Response to Biodiversity Conservation Division
advice on Response to Submission report

Valley of the Winds – Response to BCS Advice on RtS

ACEN Australia

Figure 7: Dichanthium survey - Targeted flora surveys within the Girragulang Road cluster

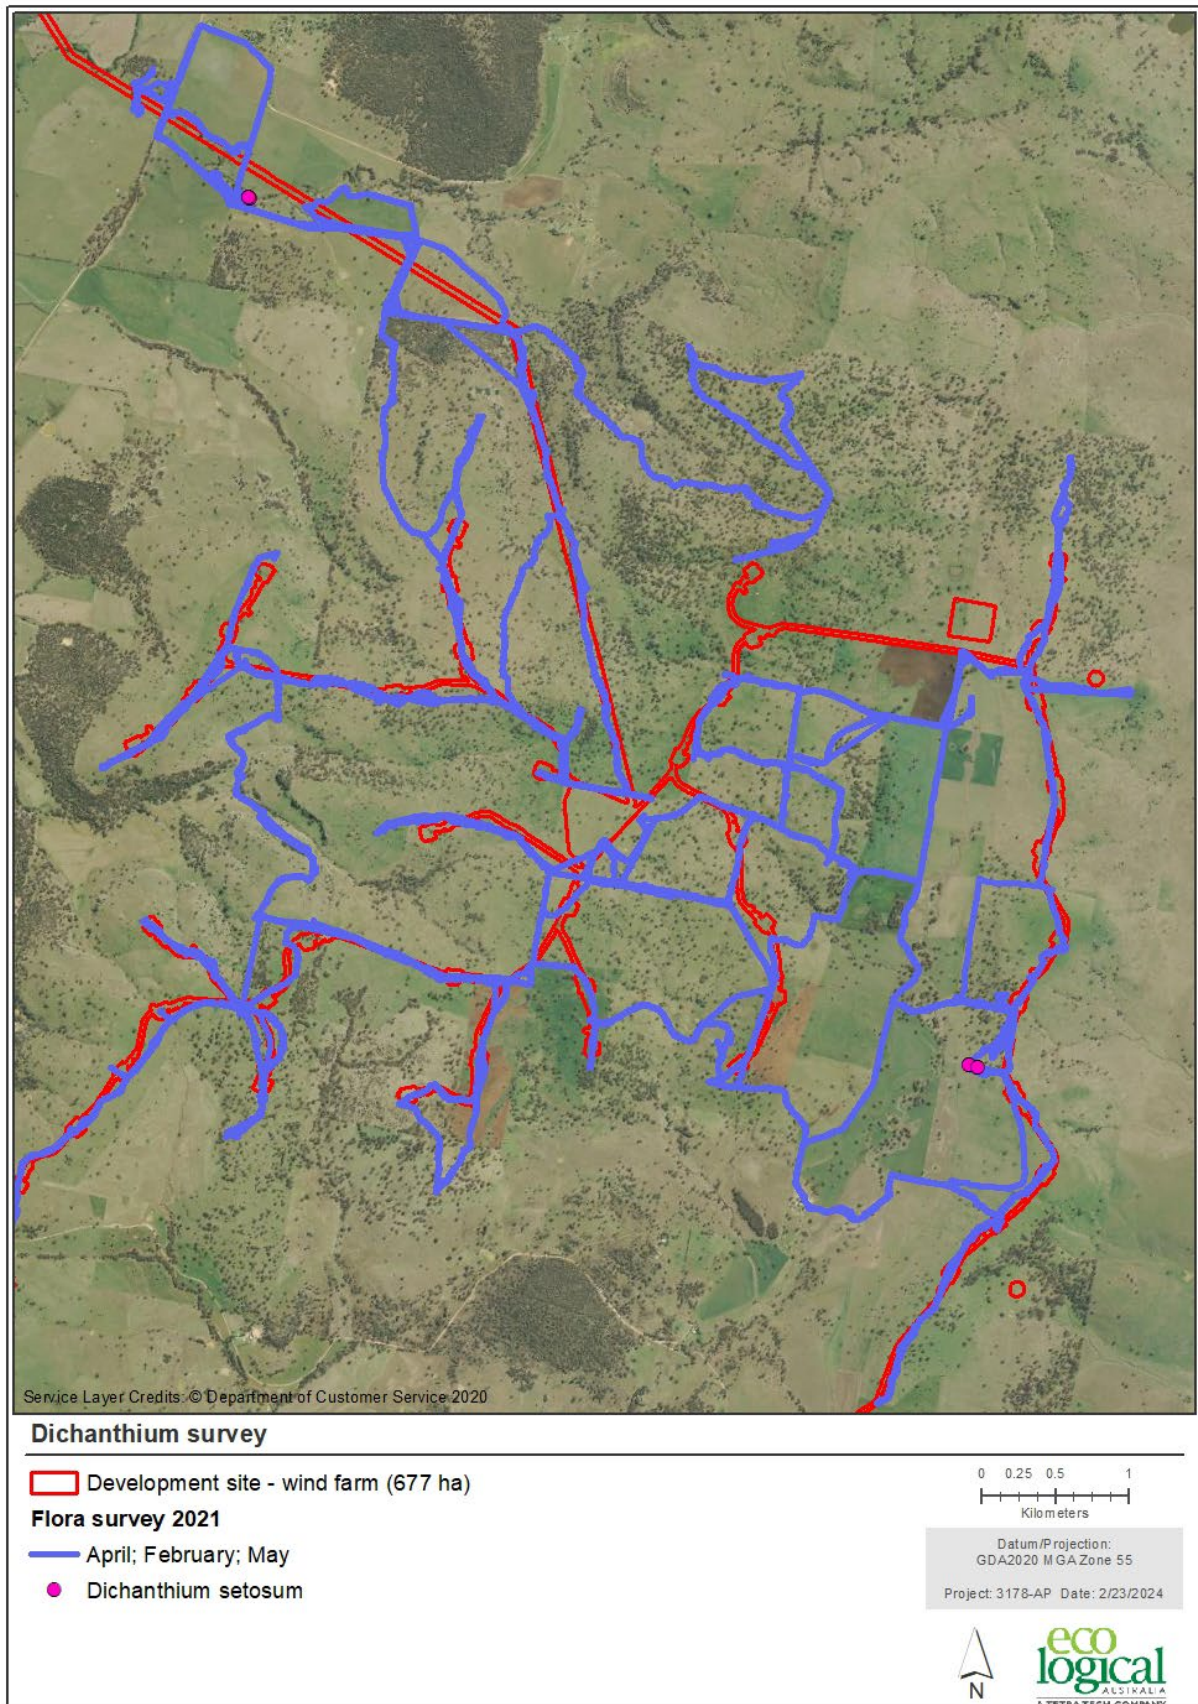
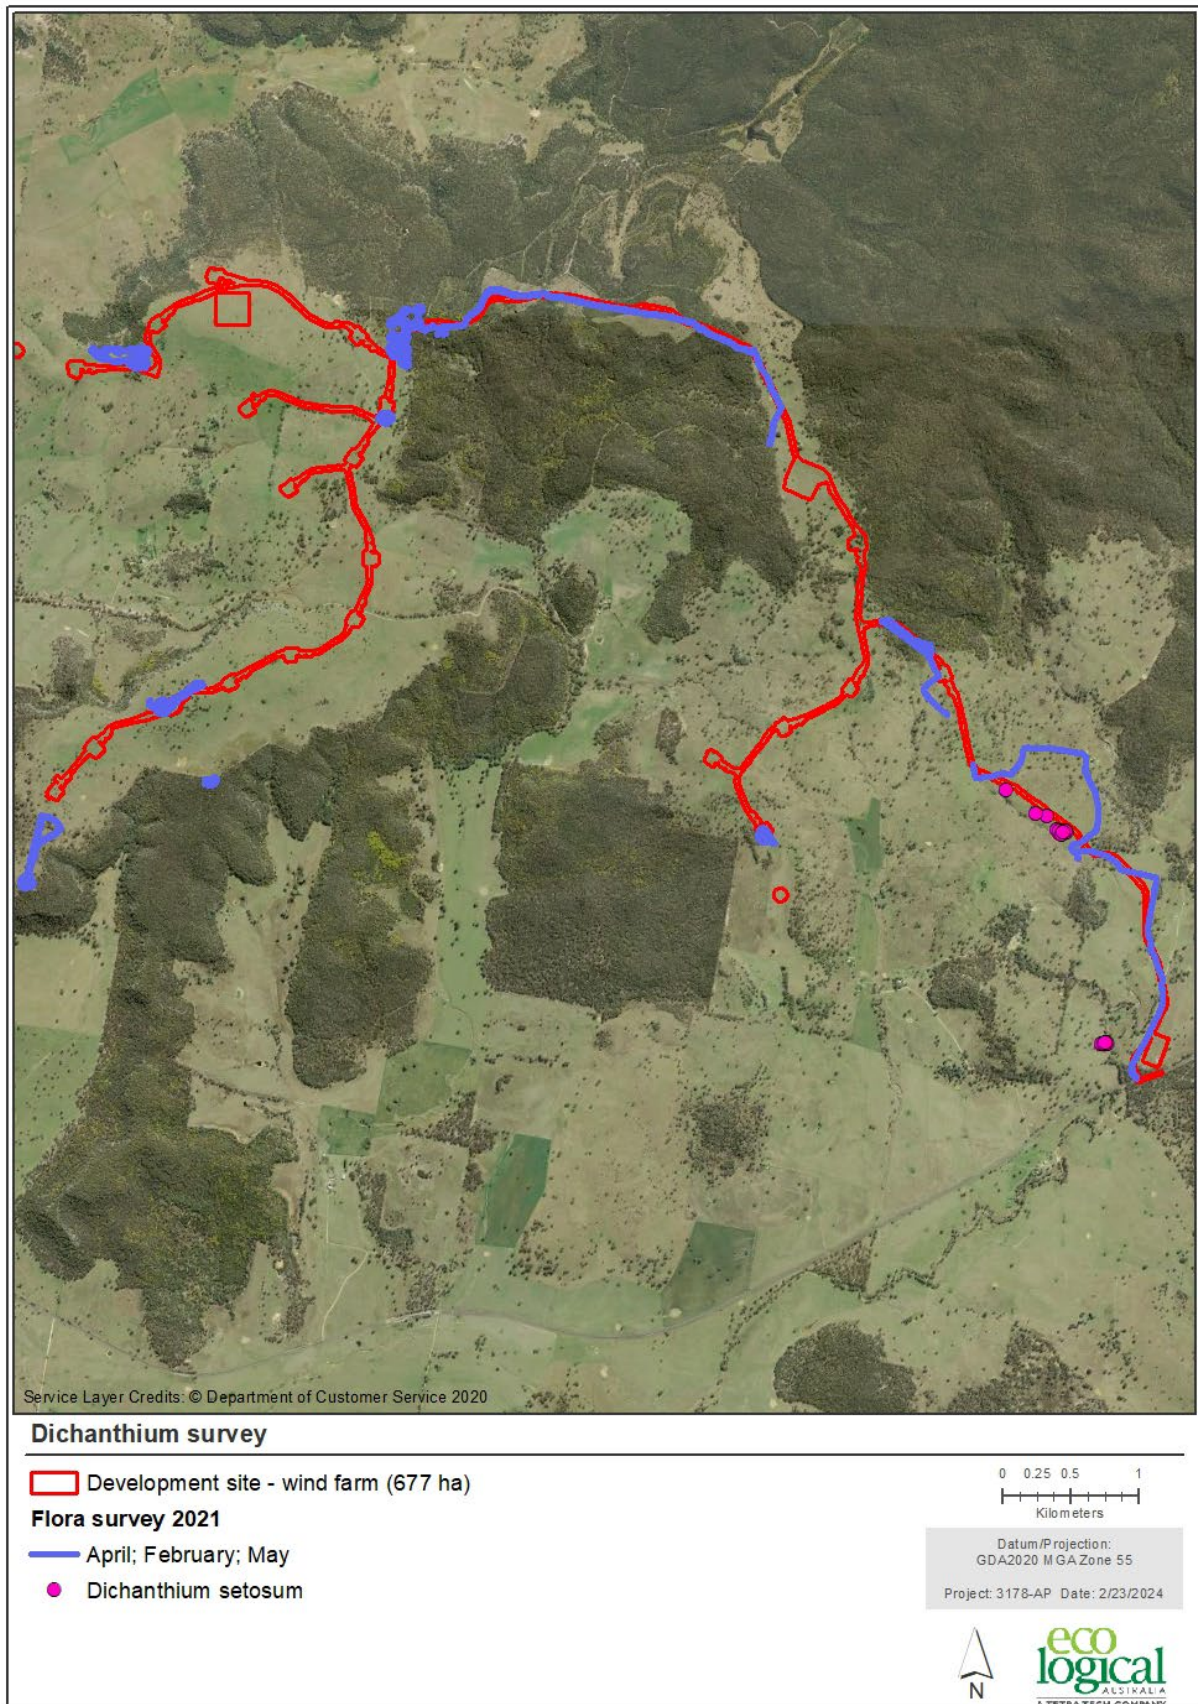
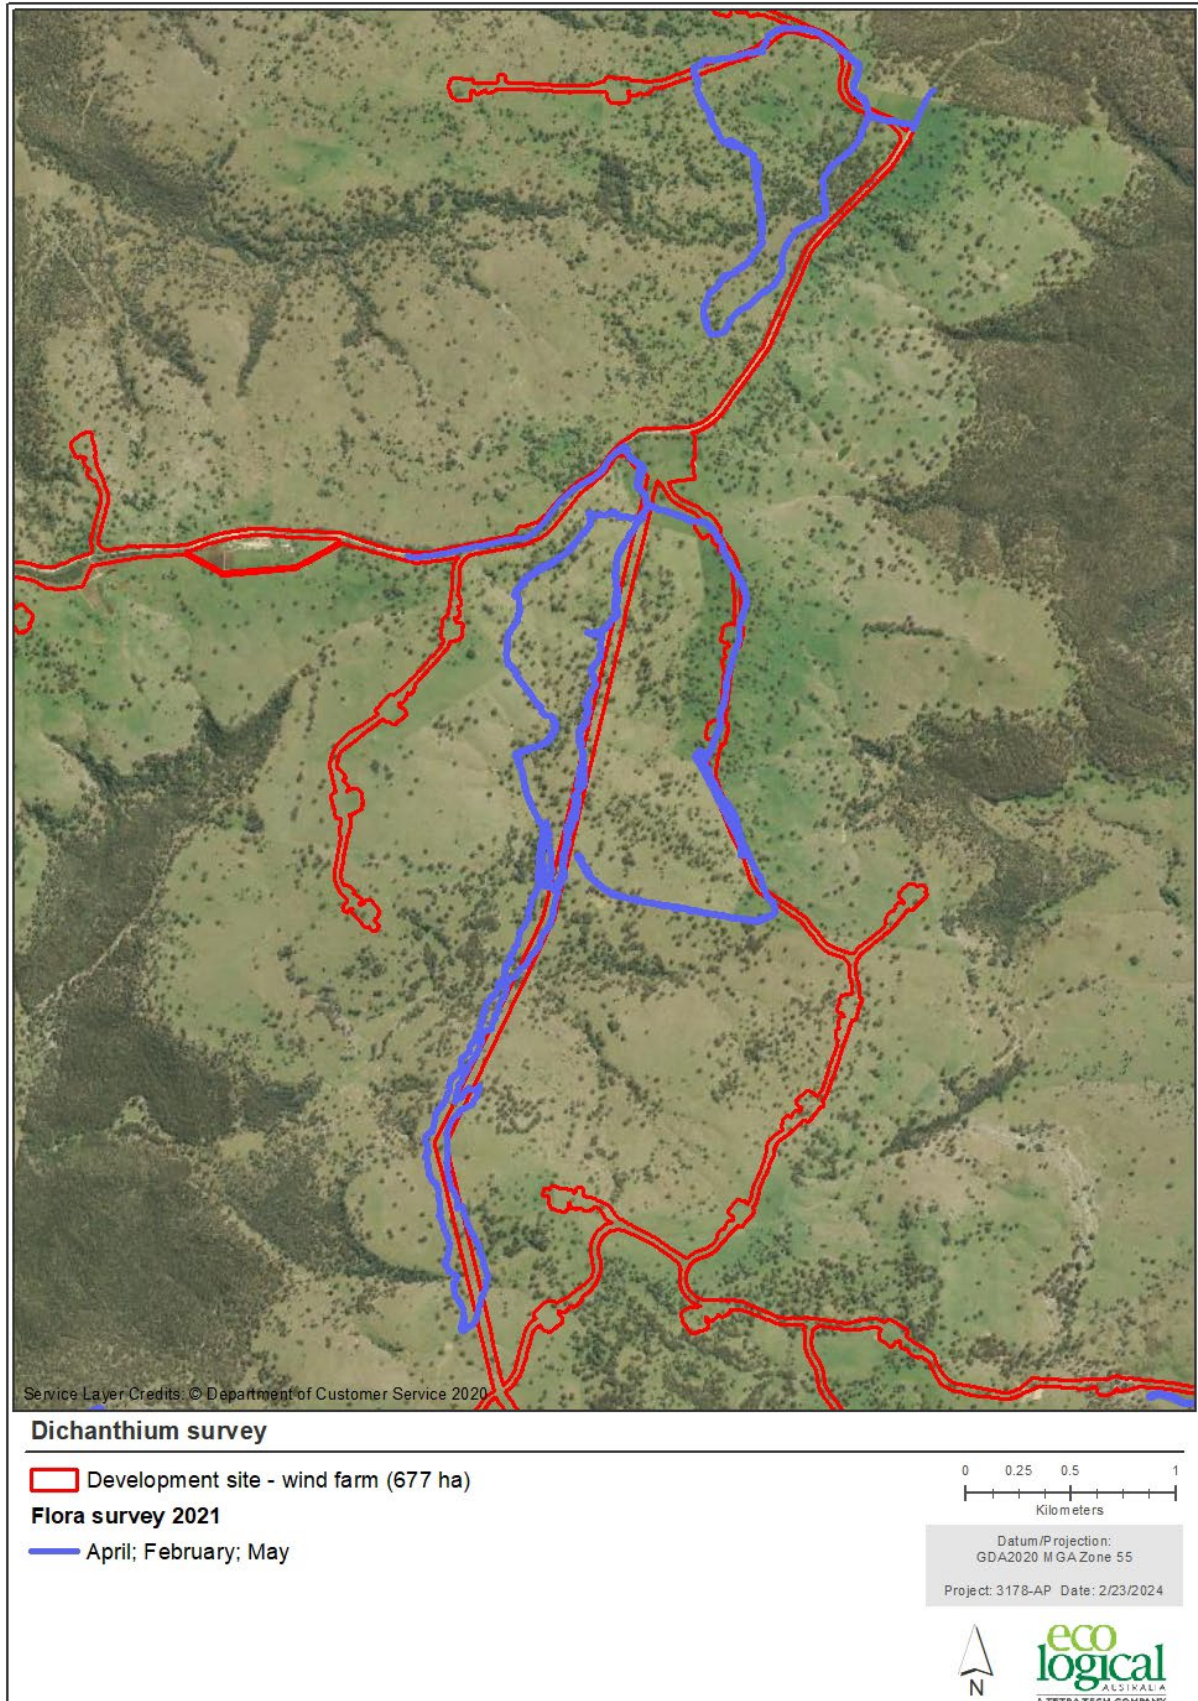
11.1 Conduct additional targeted surveys for bluegrass in all associated PCTs across the Project. Alternatively obtain an expert report, or assume presence and generate a revised species polygon for bluegrass.

The assessor suggests that a complete walk of the whole project is unreasonable for the reasons outlined below. Surveys for threatened flora species across the development site were conducted over several months in 2021, and field teams conducted targeted surveys in areas of suitable habitat. Suitable habitats are patchy across the landscape, and there is significant areas of unsuitable habitat within the development site. Close up figures of summer survey effort are shown on Figure 7 to Figure 9.

No additional surveys are proposed.

Figure 17: Rocky Areas - Rocky habitat within the study area

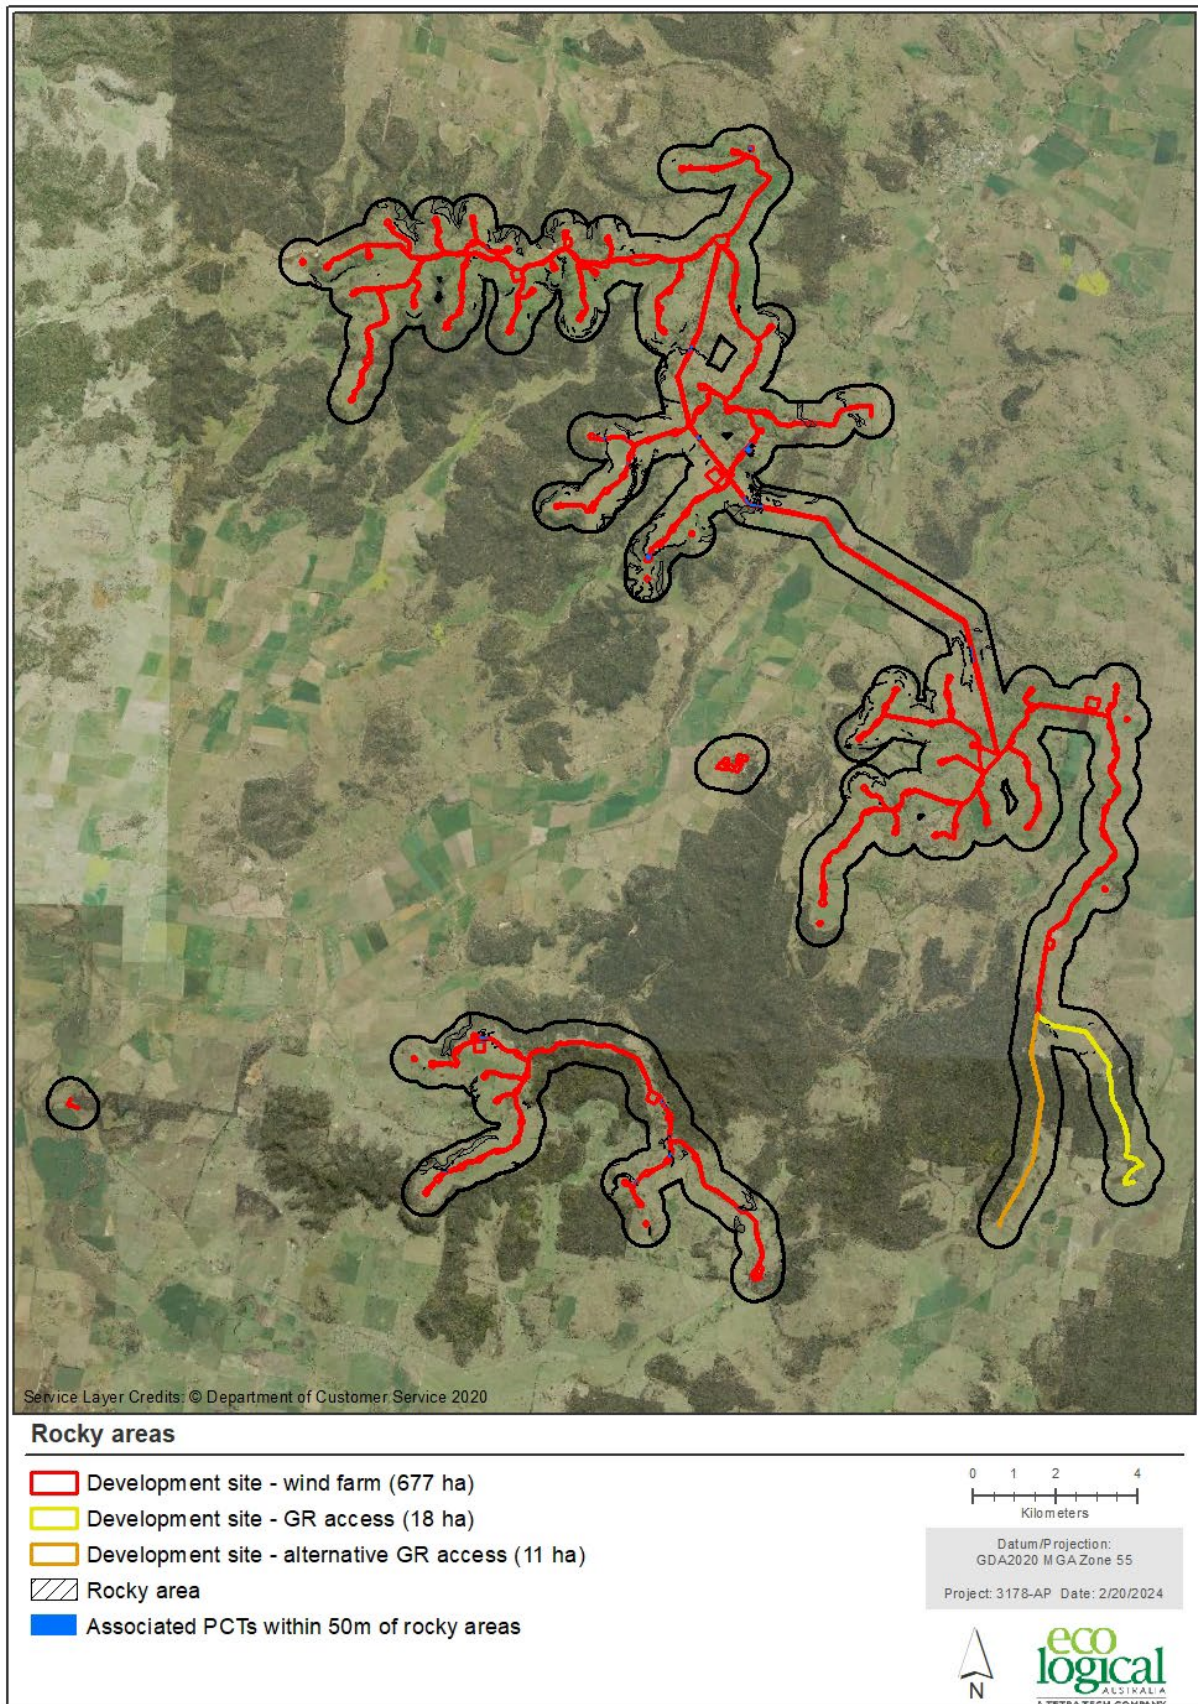
22.1 Provide mapping of rocky habitat so BCS can review the adequacy of targeted reptile surveys.

During September 2021, ELA conducted ten reptile searches (spread across all three wind turbine clusters), in accordance with the *Threatened Biodiversity Survey and Assessment: Guidelines for Developments and Activities Working Draft* (DEC, 2004), which requires two 30 minute searches (on separate days) for every 200 ha of potential habitat (Figure 16). During September 2021, ELA conducted ten searches for threatened reptiles (approximately 500 rocks turned), within areas of suitable habitat.

A map of rocky habitat has been created and is provided in Figure 17, and supplied as a spatial file for review. The polygon has been developed in accordance with the TBDC, by mapping rocky habitat within the study area, and buffering by 50m to capture all associated PCTs for *Aprasia parapulchella* (Pink-tailed Legless Lizard). A total of 17.03 ha of potential habitat is present for the species. ELA notes that this 17.03 hectares of habitat is spread across multiple patches across the development site.
